Access Compliance Report

Public Rights-of-Way

(Curb Ramps)

Intersection ID: 30304	Main Street: CHALLENGER_DR	Cross Street: EUROSTAR_DR	Location: N
ADA ID: E1D3085911BF	Ramp Type: PerpDiag	Initial Pass/Fail: Fail	Overall Compliance: No
Severity Score: 26.25			
Codes/Mitigation Info/Possible Solution		Field Measurements/Component Compliance

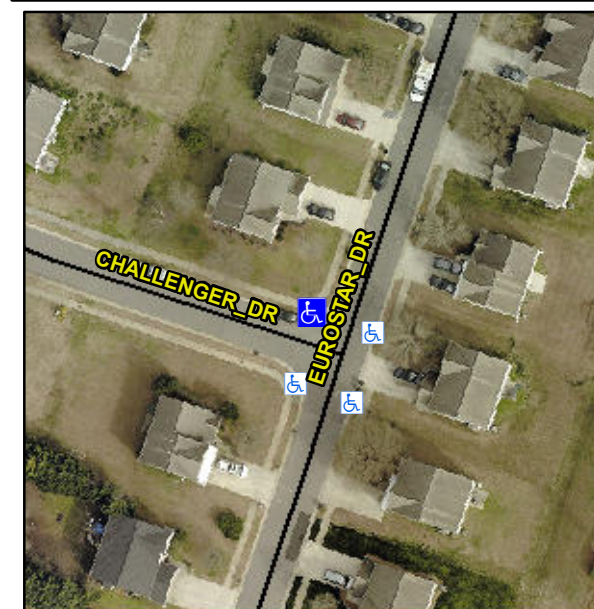
Not Found, R304.2.2, R304.5.3

Compliance	Description	Data	Compliance	Description	Data
N/A	Ramp Length (in)	48.5	No	Ramp Slope (%)	13.3
Yes	Ramp Width (in)	52.0	No	Ramp XSlope (%)	4.5
N/A	Flare Type LT	N/A	N/A	Flare Type RT	N/A
N/A	Flare Slope LT (%)	N/A	N/A	Flare Slope RT (%)	N/A
N/A	Flare Traversable LT?	N/A	N/A	Flare Traversable RT?	N/A
N/A	Landing Length (in)	N/A	N/A	DWS Provided?	N/A
N/A	Landing Width (in)	N/A	N/A	DWS Contrast?	N/A
N/A	Landing Slope (%)	N/A	N/A	DWS Length (in)	N/A
N/A	Landing X Slope (%)	N/A	N/A	DWS Full Width?	N/A
N/A	Landing Curb? (Y/N)	N/A	N/A	DWS Offset (in)	N/A
N/A	Shared Landing?	N/A			
N/A	Gutter Ponding?	N/A	N/A	Gutter Slope (%)	N/A
N/A	Gutter Lip Ht (in)	N/A	N/A	Gutter X Slope (%)	N/A
N/A	Painted X Walk1?	No	N/A	Painted X Walk2?	No
	X Walk 1 Direction	To SW		X Walk 2 Direction	To SE
N/A	X Walk 1 Width (in)	N/A	N/A	X Walk 2 Width (in)	N/A
	X Walk 1 Slope (%)	3.7		X Walk 2 Slope (%)	0.9
	X Walk 1 X Slope (%)	2.6		X Walk 2 X Slope (%)	3.0

Remove & Replace Curb Ramp With Two New Directional Ramps or Equivalent.
